From: David Sibley**Sent:** Monday, July 02, 2012 2:29 PM**To:** Jones, William V., EMNRD**Cc:** Stan Bishop; drcatanach@netscape.com; Ernest Padilla**Subject:** Responses:.... Disposal administrative application from LRE Operating, LLC: proposed Eddy-Humble "4"

From: "Jones, William V., EMNRD" <William.V.Jones@state.nm.us>
Date: June 11, 2012 8:49:54 PM EDT
To: "David Sibley" <dsibley@limerockresources.com>
Cc: <drcatanach@netscape.com>, <padillalaw@qwestoffice.net>, "Ezeanyim, Richard, EMNRD" <richard.>
Subject: Disposal administrative application from LRE Operating, LLC: proposed Eddy-Humble "4"

Name: Eddy-Humble_4_State_COM_#1_SWD_Proposed_WBS_REV3_6-29-12.xlsx

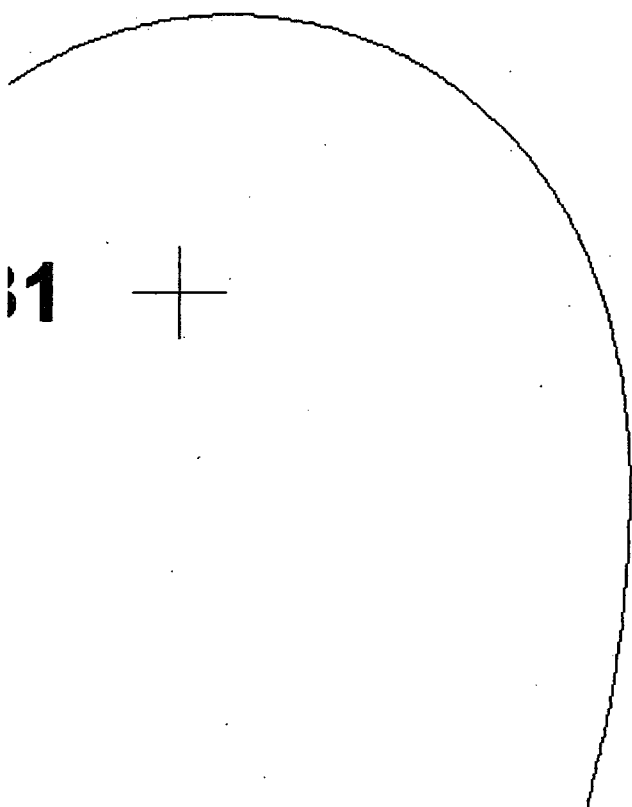
- <!--[if !supportLists]-->a. <!--[endif]-->About a mile to the SE, the Cisco was tried as a completion prior to plug
- <!--[if !supportLists]-->b. <!--[endif]-->Would you comment on what sort of mudlogging or logging you plan to
- <!--[if !supportLists]-->c. <!--[endif]-->Please ask Mewbourne where the DV tool is on the 30-015-29688 well.
- <!--[if !supportLists]-->d. <!--[endif]-->The State Engineer's site has no fresh water wells within a mile – has LI
- <!--[if !supportLists]-->e. <!--[endif]-->What is the best guess for the top of the Strawn at this location?
- <!--[if !supportLists]-->f. <!--[endif]-->The projected cement top for the 7 inch casing is only to the intermediat

f) Please see the attached revised well bore diagram, showing designed TOC at 2,600'.
